**RTB Correction**Reissue date: **15- Jun -97**

Model: AD-1		Date: 19-Mar-97	No: 26A
Subject: Paper jam		Prepared by: M.Horiike	
From: QAC 2nd Field Information Dept.			
Classification:	<input type="checkbox"/> Troubleshooting	<input checked="" type="checkbox"/> Part information	<input type="checkbox"/> Action required
	<input type="checkbox"/> Mechanical	<input type="checkbox"/> Electrical	<input type="checkbox"/> Service manual revision
	<input type="checkbox"/> Paper path	<input type="checkbox"/> Transmit/receive	<input type="checkbox"/> Retrofit information
	<input type="checkbox"/> Other (    )

Model: AD1-Paper Tray Unit ( PS330 )		Date: 23-Jul-97	No: 36
Subject: Noise		Prepared by: K.Ugaeri	
From: QAC 2nd Field Information Dept.			
Classification:	<input type="checkbox"/> Troubleshooting	<input type="checkbox"/> Part information	<input checked="" type="checkbox"/> Action required
	<input type="checkbox"/> Mechanical	<input type="checkbox"/> Electrical	<input type="checkbox"/> Service manual revision
	<input type="checkbox"/> Paper path	<input type="checkbox"/> Transmit/receive	<input type="checkbox"/> Retrofit information
	<input type="checkbox"/> Other (       )

Model: PS

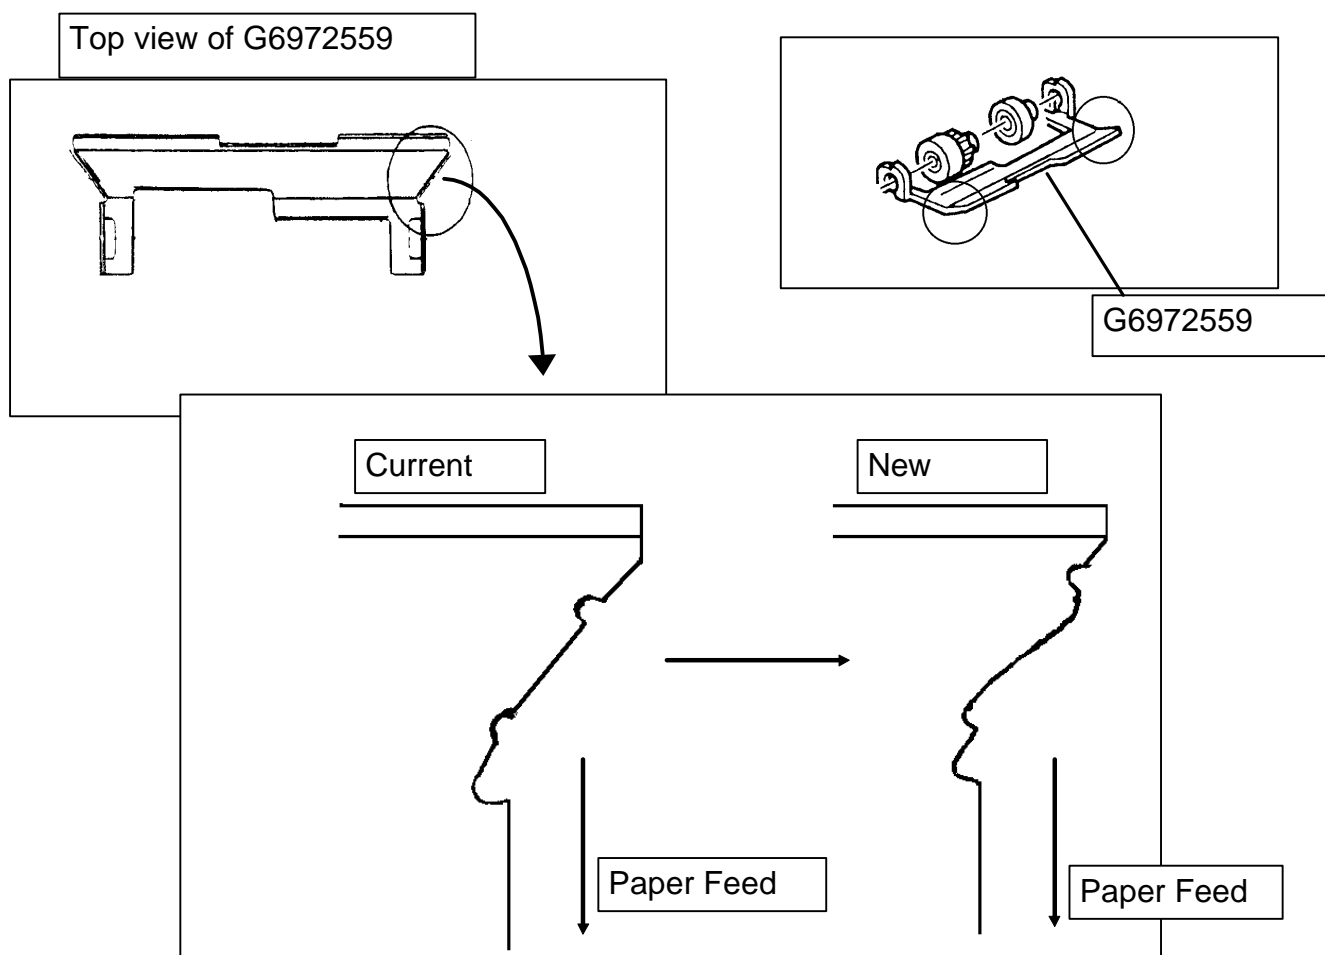
Paper jam from the ***paper tray unit (PS 330)***.

The paper contacted the uneven edge of the upper guide paper feed.

The shape of the upper guide - paper feed has been changed from January Production '97.

2. Paper Feed Section (G697)

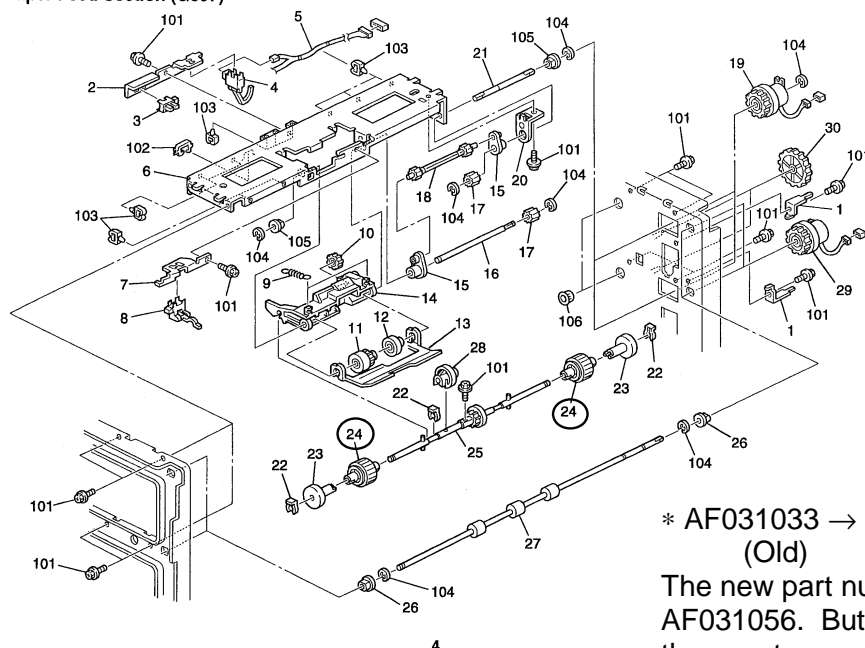
**SYMPTOM:** Paper jam

**CAUSE:** Paper skewing or no feed from PS330 (Paper Tray)

**Countermeasure:** The diameter of the paper feed roller has been modified from 30φ to 32φ to improve paper feed.

\* AF031033 → AF031056  
(Old) (New)

The new part number of the feed roller is AF031056. But do not order this part until the countermeasure kit is out of stock.
